LAND USE/SEPA DECISION APPEAL FORM

- Decision appealed (Indicate MUP #, Interpretation #, etc.): 3012953
- Property address of decision being appealed: 500 17th Ave 98122
- Elements of decision being appealed. Check one or more as appropriate:

Comments on the Swedish Cherry Hill Major Institution Master Plan and Environmental Impact Statement.

Build Alternatives

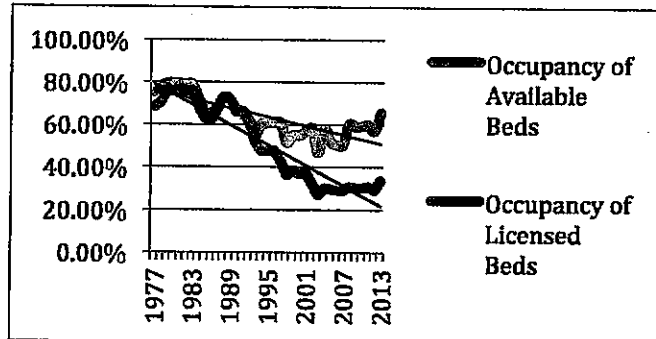
It is disingenuous to speculate that "the pattern and types of land uses on the western portion of the campus would not change substantially" when it is proposed to locate a major medical office building on the site.

#### Build Alternatives

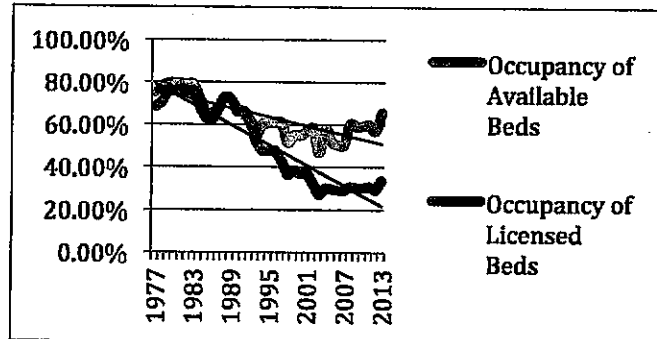
It is disingenuous to speculate that "the pattern and types of land uses on the western portion of the campus would not change substantially" when it is proposed to locate a major medical office building on the site.
